NEW ELEMENTARY SCHOOL
8601 HIGHLAND KNOLLS DR
BAKERSFIELD
CALIFORNIA
93306

NEW MIDDLE SCHOOL
4115 VINELAND ROAD
BAKERSFIELD
CALIFORNIA
93306

SHEET TITLE
ELECTRICAL MECHANICAL
PLAN BUILDING P

E-122P
SHEET OF

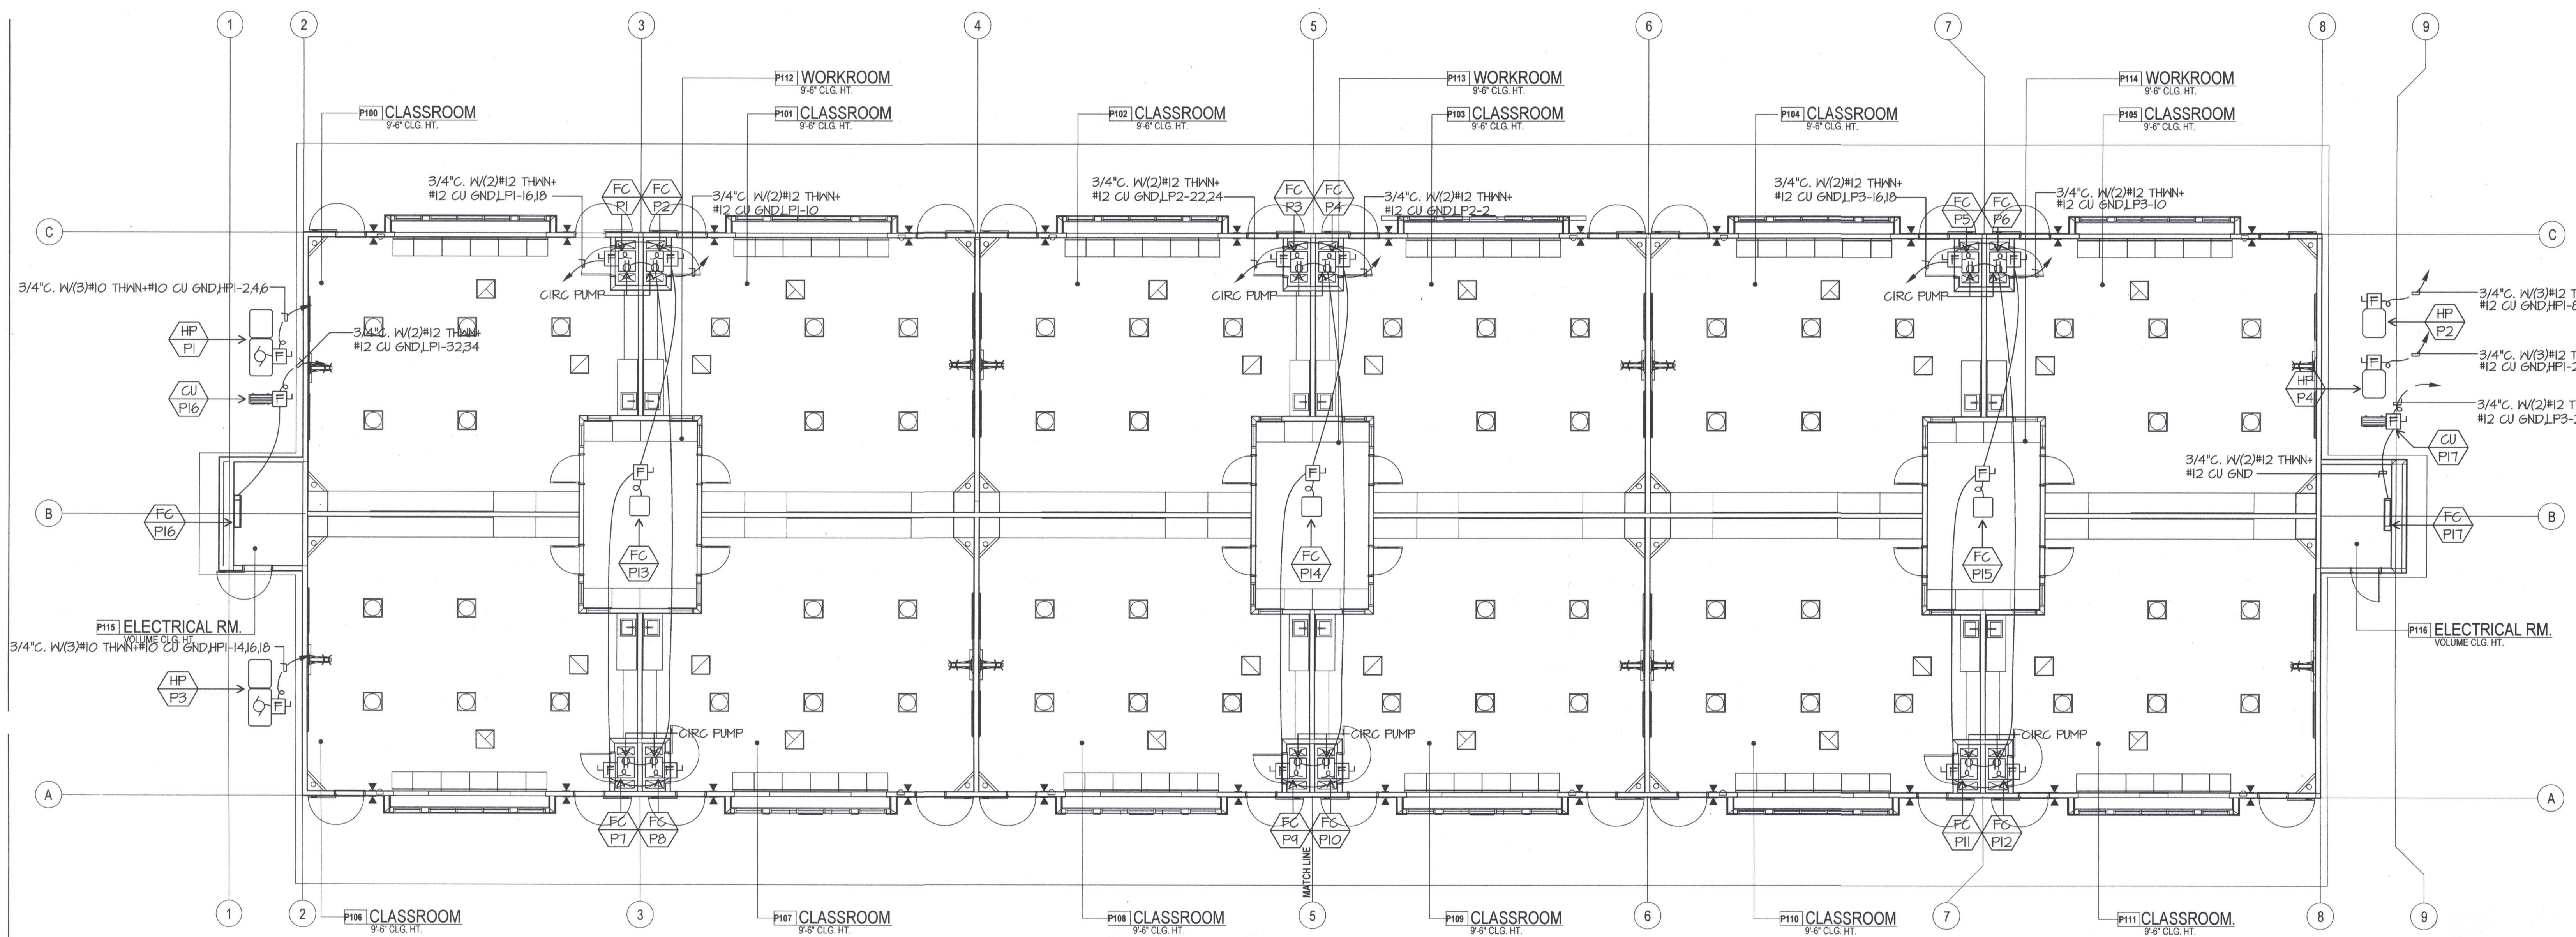
RFI 139
Request:
RDM Electric - 9/18/12
Reference Sheets E-122C, E-122D, E-122E, E-122F, E-122G, E-122H & E-122P
In the classroom buildings (C,D,E,F,G,H & P), the electrical plans show fused
disconnects to be installed for the fan coils. Due to the fan coil and ductwork,
there is not enough room to install the disconnects inside the mechanical
closets. Please advise on an alternate location for the fused disconnects for
the fan coils located in the classrooms of Buildings C,D,E,F,G,H & P.
Answer:
John Maloney JMPE - 10/2/12
It is acceptable to mount the specified fused disconnects above the ceiling.
